Project 1680

Subject: **SUPPLEMENTAL REPORT No. 1**  
23401 Cross Creek Road  
Malibu, California

## GEOTECHNICAL REVIEW SHEET

<u>Project Information</u>			
Date:	September 22, 2008	Review Log #:	2994
Site Address:	23401 Civic Center Way	Planning #:	CDP 08-066
Lot/Tract/PM #:	n/a		CUP 08-011
Applicant/Contact:	Gordon, Gordon@ekstrandenterprises.com	BPC/GPC #:	
Contact Phone #:	323-782-0505	Fax #: 323-782-0606	Planner: Bonnie Blue
Project Type:	Whole Foods Shopping Center

Reference:	US Geological Survey Geologic Map:
Project Address:	23401 Civic Center Way Malibu, California
	Plate 1

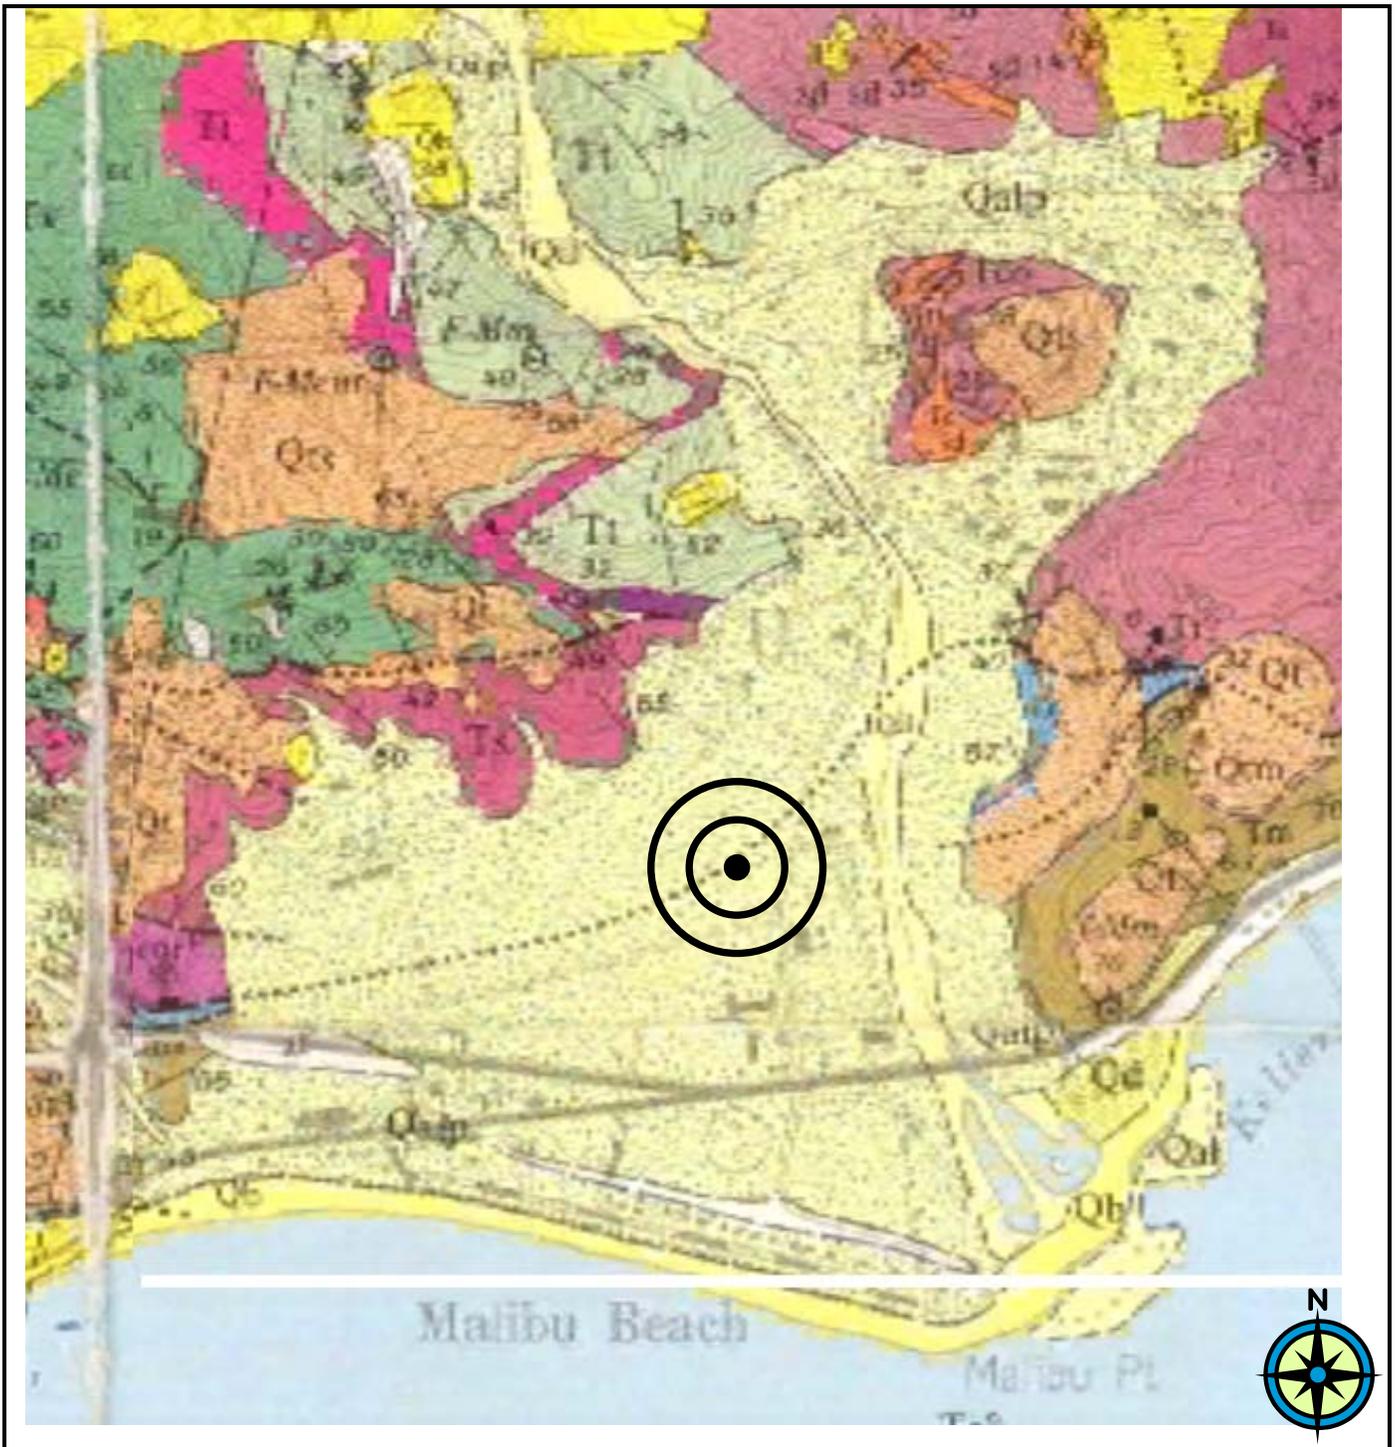
7. Please discuss the Malibu Coast Fault on the site. Is there a fault rupture hazard on the site?

Item #7: The site is within an area of mapped potentially active faults as related to the definition by the State of California. The main trace of the Malibu Coast fault is regionally mapped within the central portion of the property, (Campbell 1996 - Plate 1). The Malibu Coast fault is mapped along the southern portion of the site near Civic Center Way, (Dibblee 1993 - Plate 2). The fault map by CDMG Treiman (Plate 3) depicts both fault tracts by the US Geologic Survey and the Dibblee Geologic Foundation. Regionally, the main trace of Ground rupture is the result of movement from an active fault. As of June 1995, two portions of the Malibu Coast fault zone were reclassified as active fault zones by the State of California. On August 16, 2007, the fault zone near the east side of Malibu Bluff Park was removed from the State of California Earthquake Fault Zone map by the California Geologic Survey. The Malibu Coast fault consists of several subparallel strands in a zone as wide as 0.5 km, with a length of at least 17 miles. It strikes east west and dips (45) to (80) degrees to the north.

No evidence of active faulting was exhibited within the seismic trenches on the subject site. Therefore, no known active fault is anticipated to daylight beneath the limits of the proposed structure.

LATERAL DESIGN  
 SLOPING SURFACE-

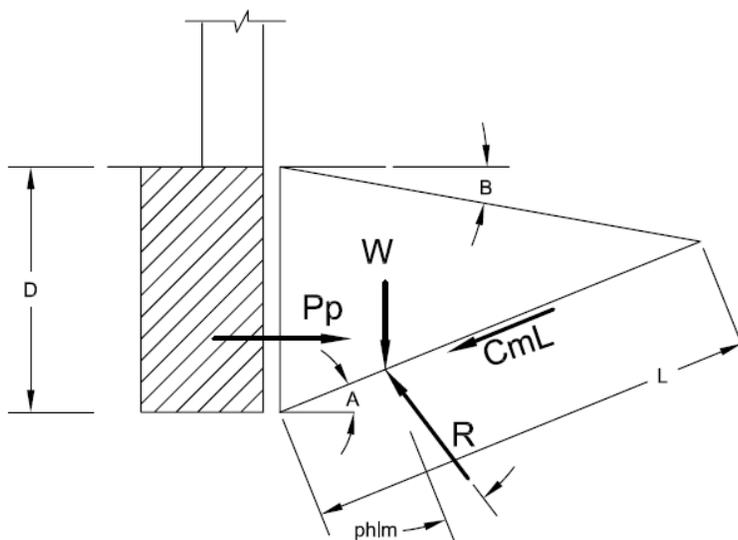
3. Please clarify whether the recommended passive resistance and coefficient of friction are allowable or ultimate values, and provide supporting calculations. Please refer to Section 7.1.1 of the City's geotechnical guidelines concerning lateral resistance (e.g., amount of cohesion that may be used in computing the passive resistance, having test results at low effective overburden pressures, and the required safety factor when the lateral resistance is increased for short-duration loadings), and revise recommendations as necessary.

Item #3: The proposed grading plan indicates raising the elevation about (4) feet. Assuming the proposed compacted fill shear strength parameters are  $C=200$  psf and  $\phi=30$  degrees the following foundation design parameters are provided. The compacted fill shear strength should be determined during the compacted fill placement.

Lateral loads may be resisted by friction at the base of the conventional foundations and by passive resistance within the recommended compacted fill. A coefficient of friction of (0.35) may be used between the foundations and the compacted fill. The passive resistance may be assumed to act as a fluid with a density of (300) pounds per cubic foot. A maximum passive earth pressure of (3000) pounds per square foot may be assumed.

Depth of Embedment, (D):	2.0 ft.
Soil Phi, (phi):	30 deg.
Soil Cohesion, (c):	200 psf
Soil Density, (g):	120 pcf.
Slope Angle, (B):	0 deg.
Safety Factor Applied:	1.5 FS

Coefficient of Friction = $(\tan(\phi)/FS) =$	0.38
Minimum Passive Pressure=	643 pcf

**SECTION A-A'**

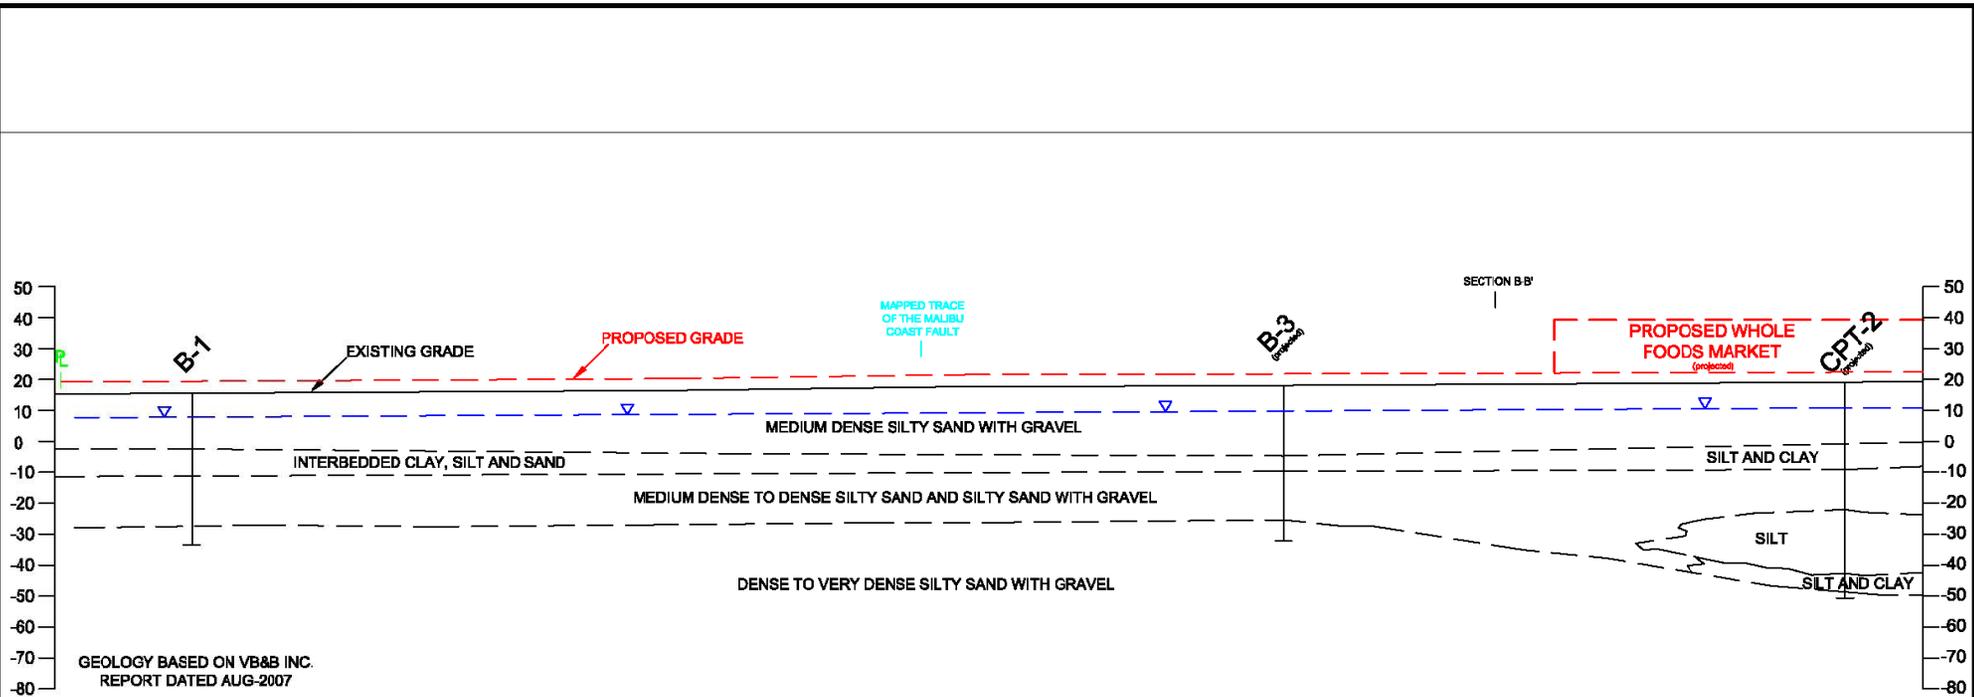
1. The report submitted does not appear to address the currently proposed development based on the site and grading plans. Please provide a report that addresses the currently proposed development. Additional recommendations shall be provided as necessary. The Geologic Map and Cross-Sections must be updated to reflect the currently proposed development.

- Item #1: Attached is an updated map based on the currently proposed development. The plan essentially depicts the site be elevated about (4) feet from the current grade.
- Item #2-6: It is our understanding that the proposed project will be connected to a future offsite waste treatment plant.
